ECE/TRANS/WP.29/GRPE/2007/9  
26 March 2007

GLOBAL TECHNICAL REGULATION No. 2 ON THE  
WORLD-WIDE HARMONIZED MOTORCYCLE EMISSION TEST CYCLE

Proposal for draft amendments to gtr No. 2

Submitted by the expert from Germany

Figure 6-1: vehicle classification

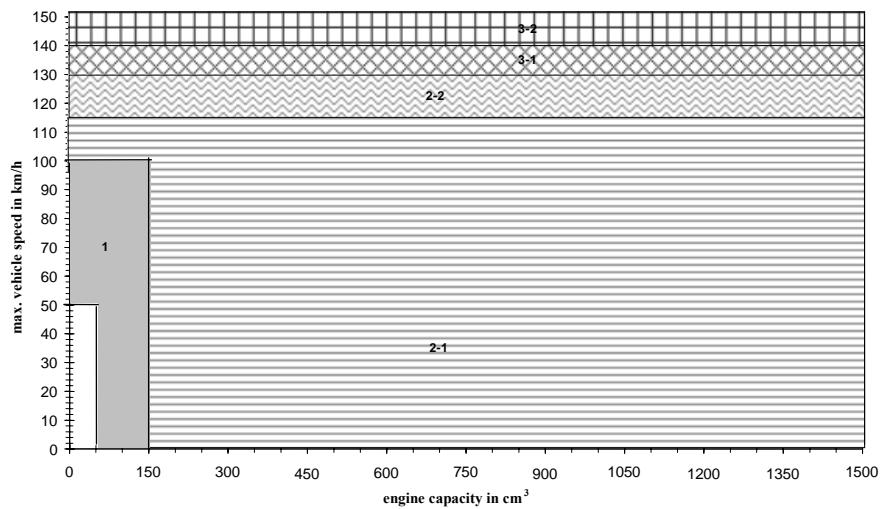
Paragraph 6.3.3., figure 6-1, replace by the following:

The amended figure graphically illustrates the new classification.

"6.3.1.    Class 1

Vehicles that fulfil the following specifications belong to class 1:

**50 cm<sup>3</sup> < engine capacity < 150 cm<sup>3</sup> and v<sub>max</sub> < 50 km/h**

**engine capacity < 150 cm<sup>3</sup> and 50 km/h ≤ v<sub>max</sub> < 100 km/h**

Annex 5, figure A5-2, replace by the following:

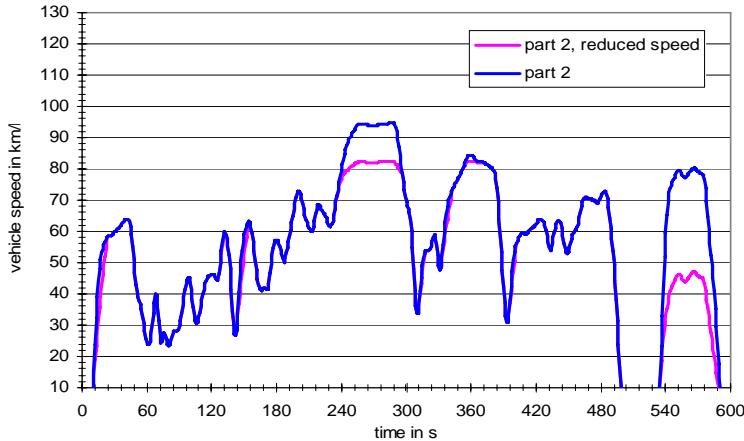
Annex 5, figure A5-2.

Amendment of test cycle part traces in line with cycle module modifications.

**Figure A13-1:** Example of a gearshift sketch for a small vehicle

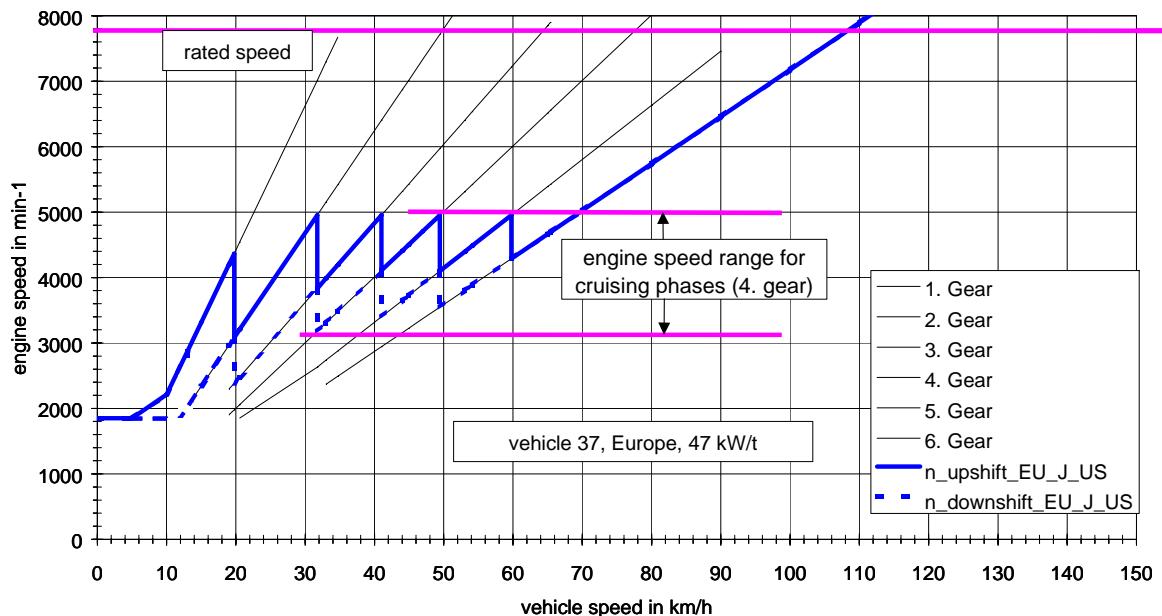
Figure A13-1 shows an example of gearshift use for a small vehicle. The lines in bold show the gear use for acceleration phases; the dotted lines show the downshift points for deceleration phases. During cruising phases the whole speed range between downshift speed and upshift speed may be used.

In order to allow to the test service more flexibility and to assure driveability the gearshift regression functions should be considered as lower limits. Higher engine speeds are permitted in any cycle phase.
